EASTERN CORRIDOR SEGMENTS II AND III (PID 86461)  
**COMBINED LINWOOD/EASTERN INTERCHANGE AND US 50/RED BANK INTERCHANGE FOCUS AREA**  
**ADVISORY COMMITTEE MEETING #2**  
R.G. CRIBBET RECREATION CENTER • MAY 22, 2018

## MEETING #2 NOTES

**Figure EW-1**  
**RECONNECT BEECHMONT COURT**

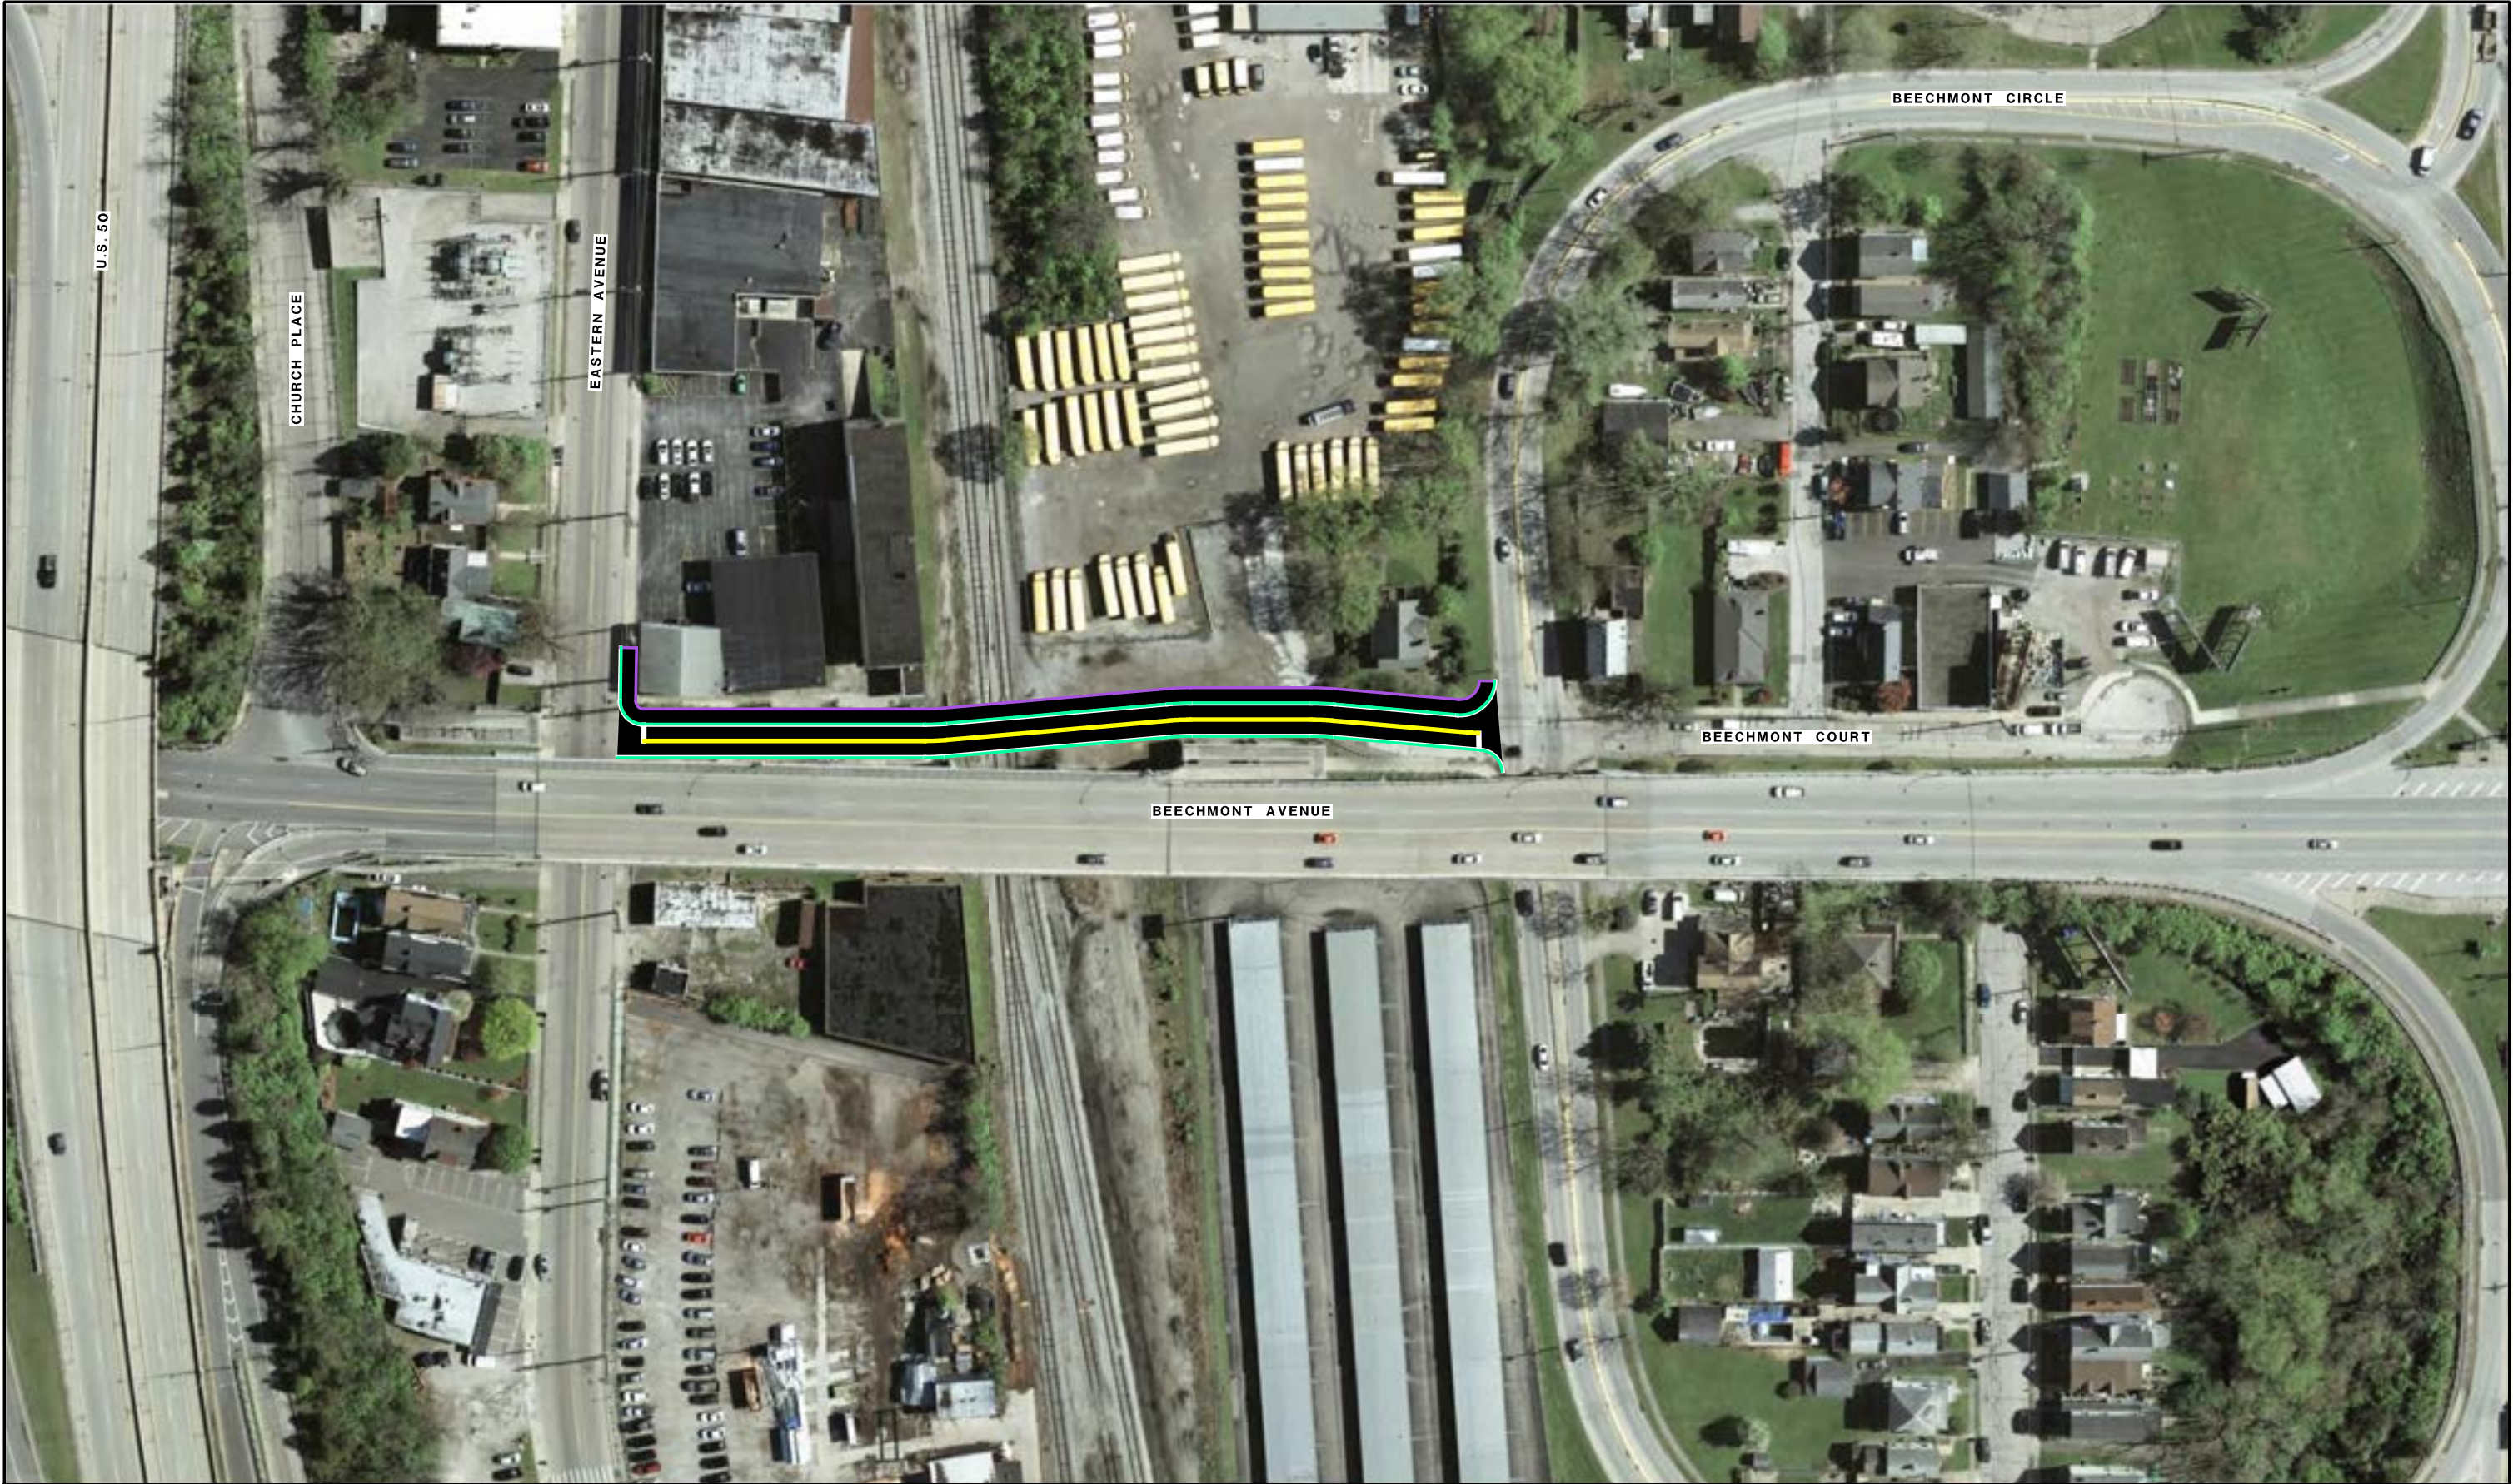
- Concept would require an at-grade railroad crossing, which may be difficult to negotiate with the rail companies.
- SORTA might have a service plan that goes through this area and it’s possible that the railroad tracks would be eliminated. J. Gardocki will confirm and report back to ODOT.
- The proposed new road in this concept is very close to the bridge to the SR 125/Beechmont Levee, which would impair visibility for the railroad.
- Concept drops traffic directly into the Beechmont Circle.
- Bike connections are better addressed through other concepts.

**Figure X-2B-3 and EW-2**  
**GRADE SEPARATED INTERCHANGE TO CONNECT**  
**WILMER AVENUE TO WOOSTER ROAD**

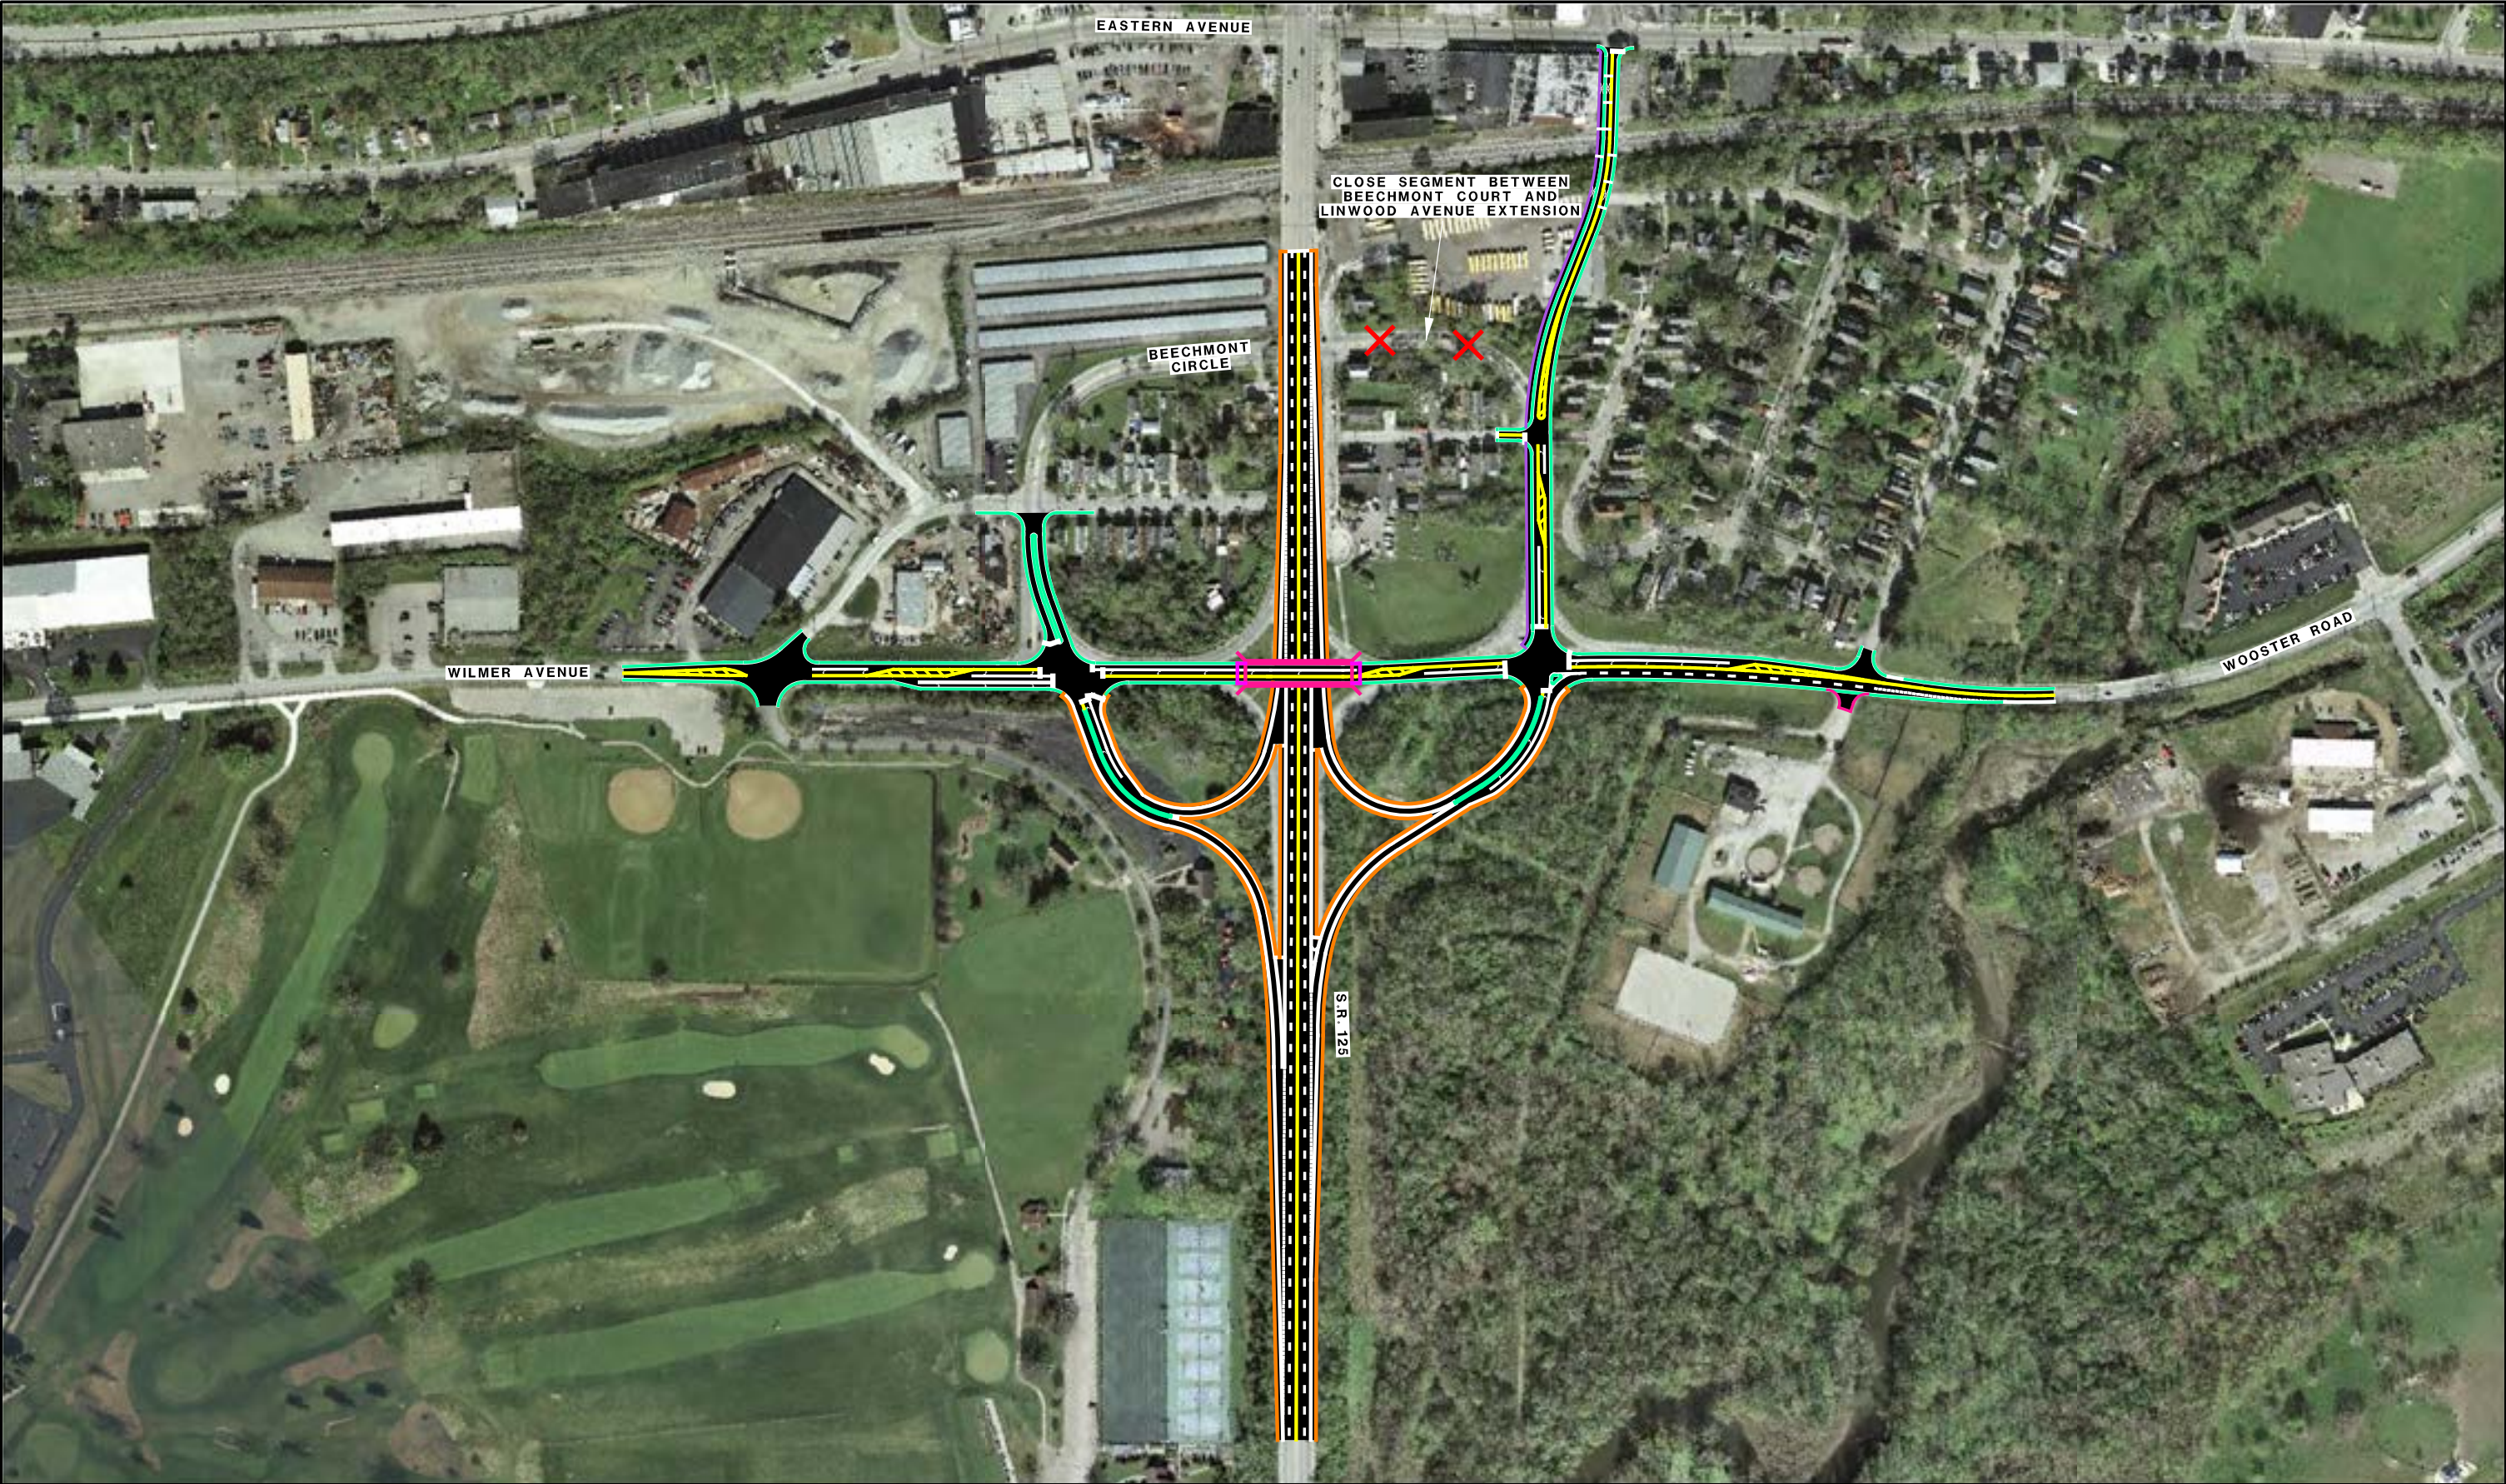
- This concept would create a new extension of Linwood (where it currently dead ends into Eastern Avenue) through the parking lot of the Company on Eastern building, across the railroad tracks and through to the eastern-most portion of Beechmont Circle.
- The concept ties better into Beechmont Circle than concept EW-1 but would impact the existing building.

**Figure I-29B & X-3B**  
 CLOSURE OF GEOMETRICALLY DEFICIENT RAMP FROM  
 EASTERN AVE TO S.R. 125 AND REPLACEMENT WITH  
 INTERSECTION AT LINWOOD AVENUE

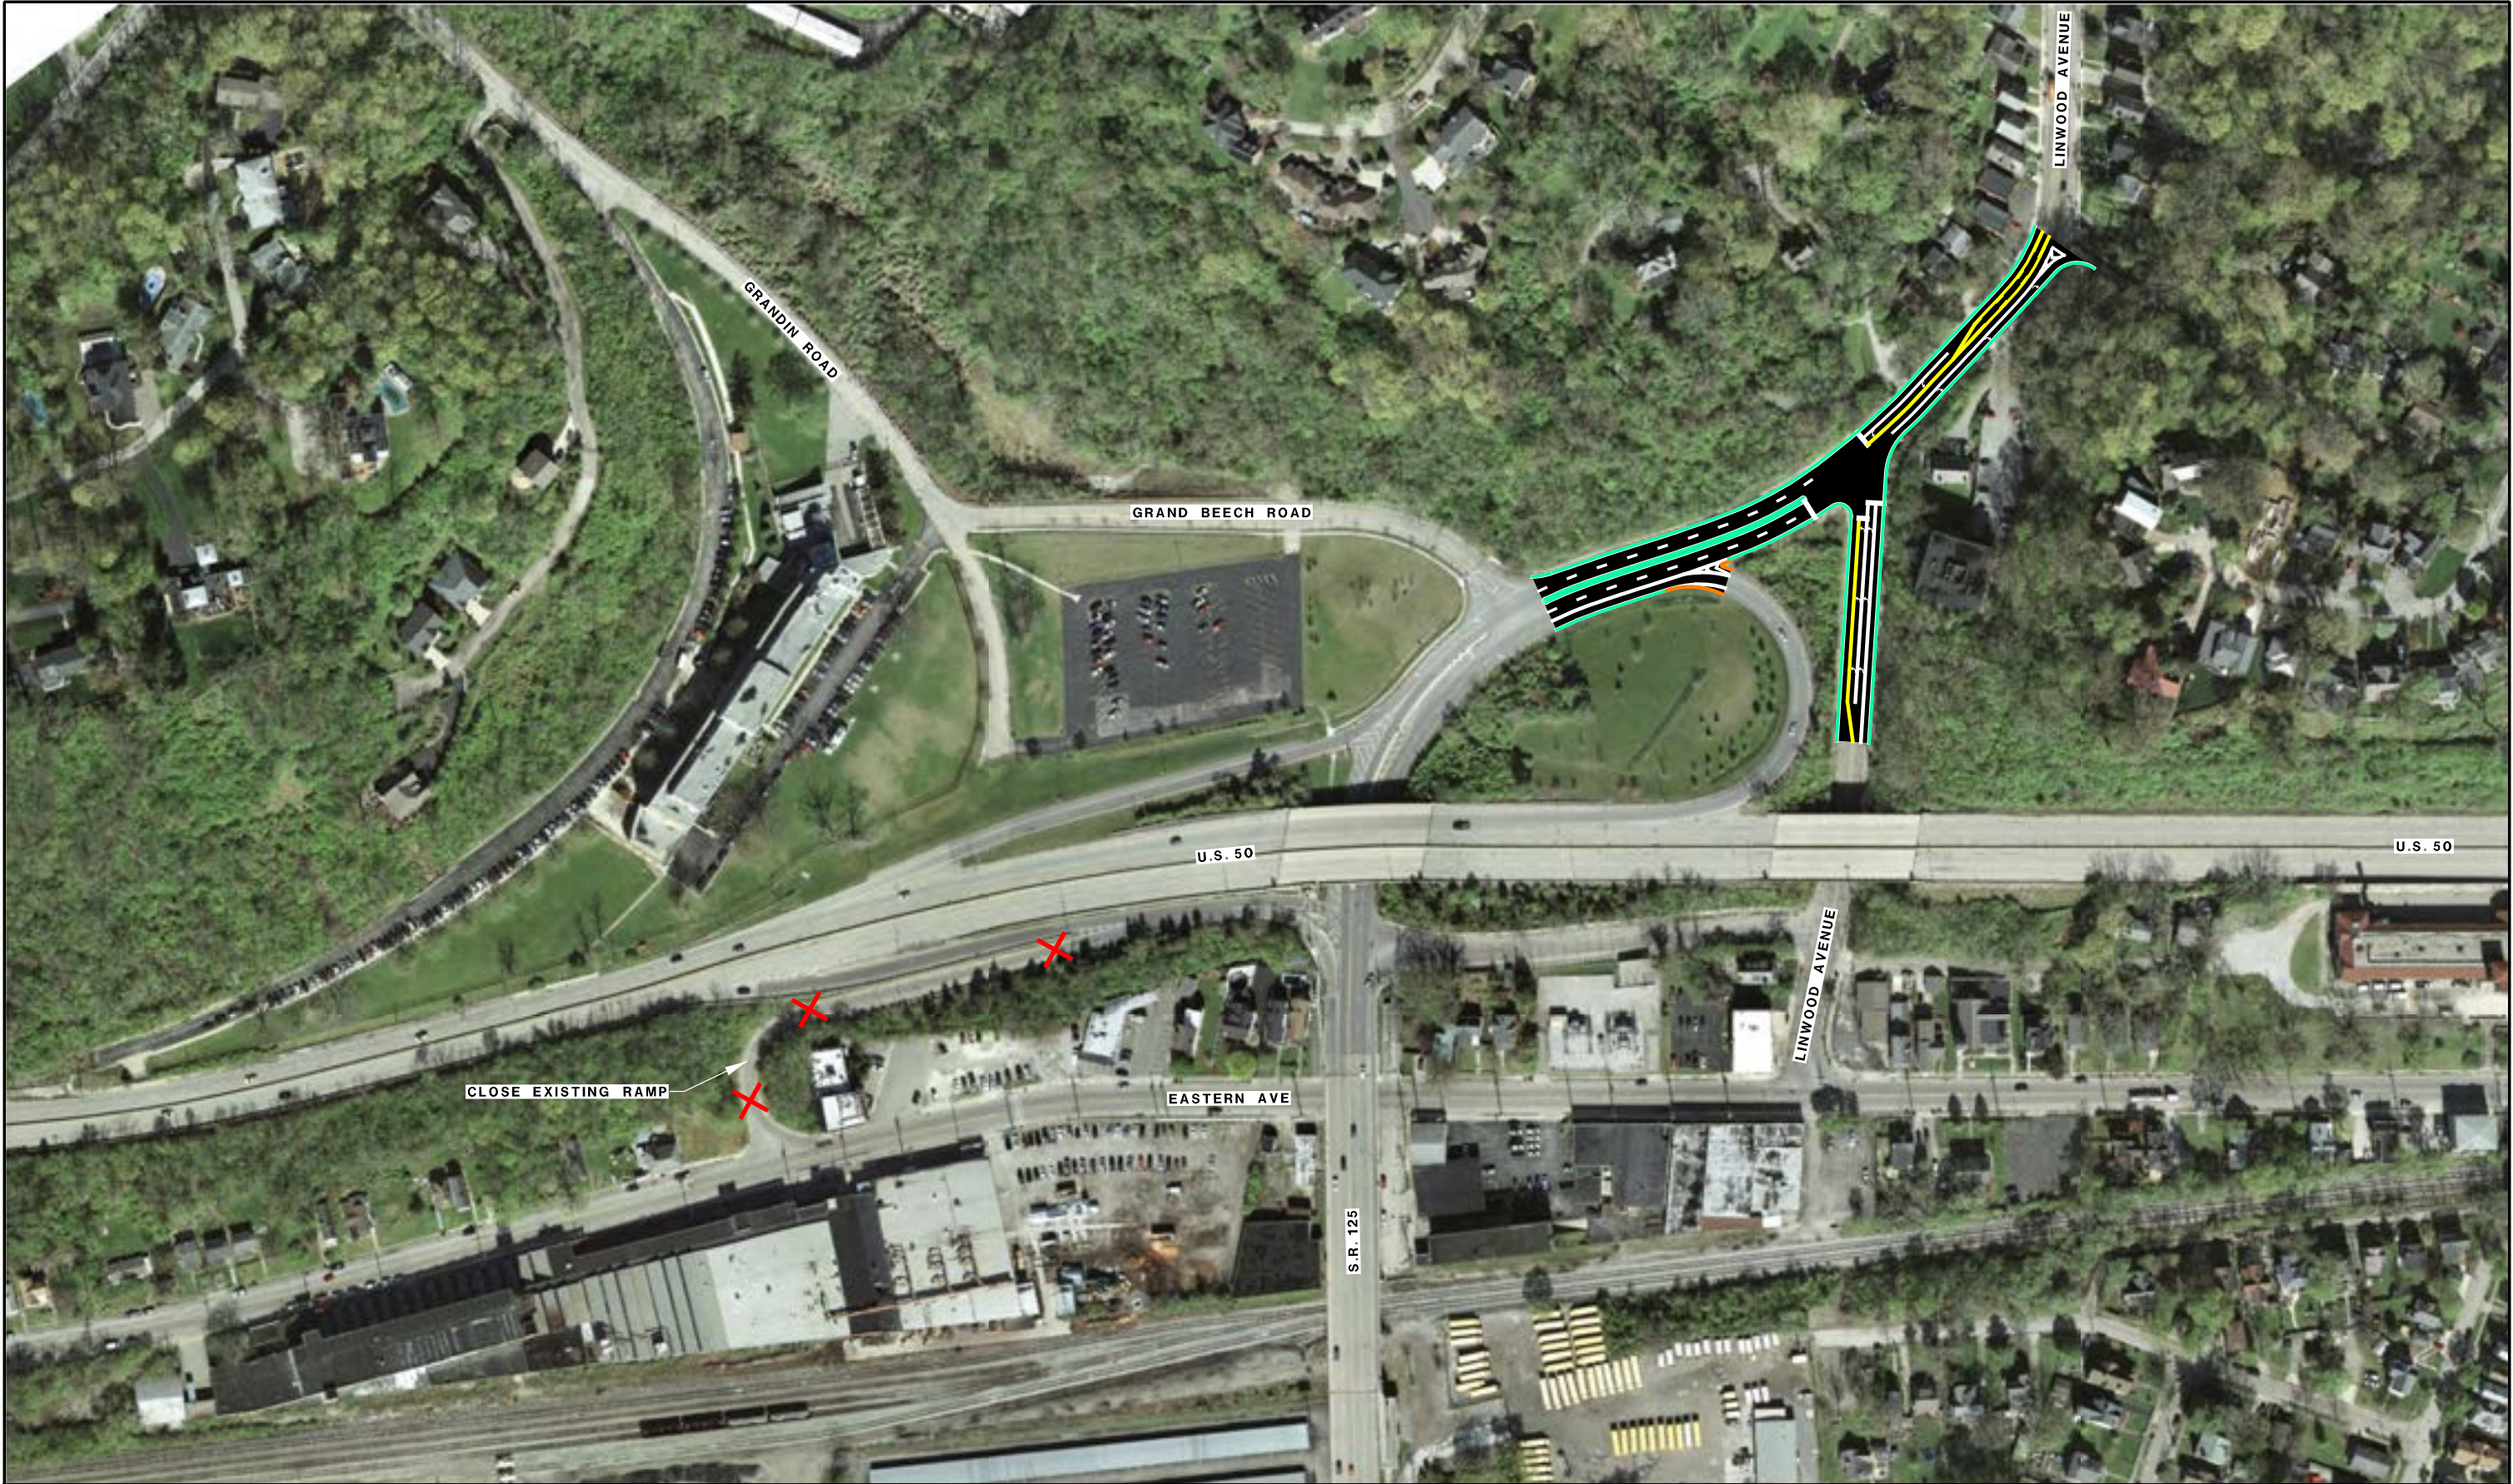
- Requires two westbound lanes on Linwood Avenue.
